SUBJECT: AMENDMENT TO RLL-1 SERIES REGISTRY

REF. REGISTRY: KY-576-D-113-B

DATE: 3/22/01            RESUBMITTED WITH CLARIFICATIONS PER  
TELEPHONE CONVERSATION ON 4/18/01

MODEL: RLL-1 SERIES

<b>ROVAN</b> MEASUREMENTS DIVISION			
CLIENT	SCALE	DR. BY RMC	
	NTS	DATE BY	
TITLE: INSTALLATION: MOUNTING RLL-1 SOURCE HOLDER ONTO VESSEL (PIPE)			
NOI	ISSUE NUMBER	REV.	
11/16/98	D-16070-K	3

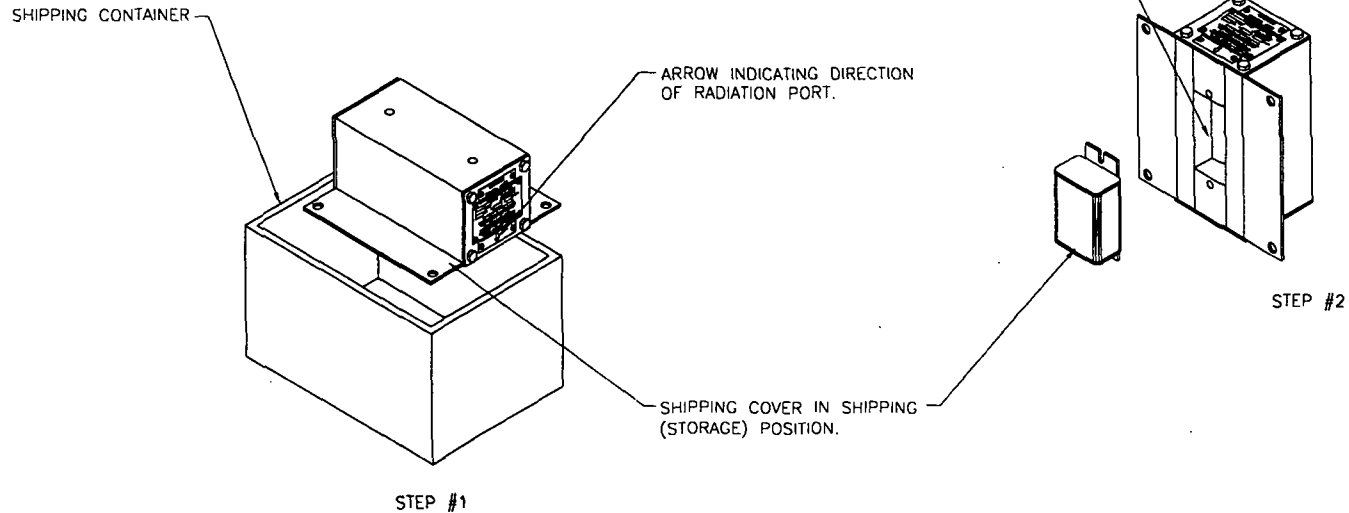
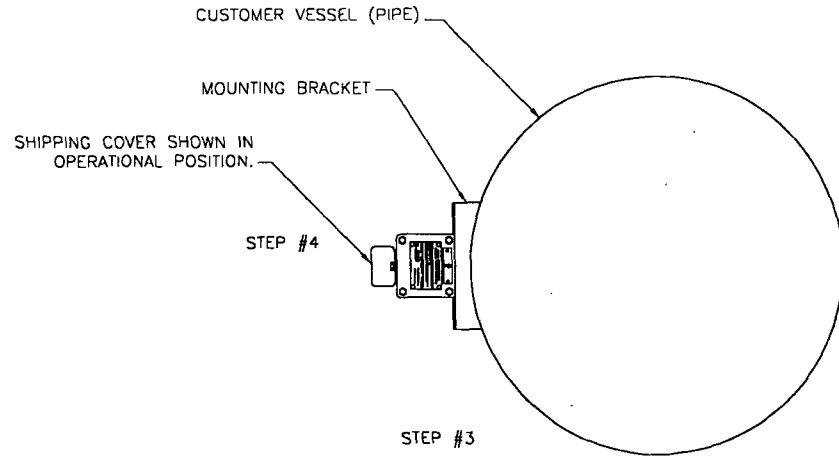
CORRECTED PICTORIAL VIEW OF SOURCE HOLDER IN THE INSTALLATION  
INSTRUCTIONS RONAN DRAWING D-16070-K.
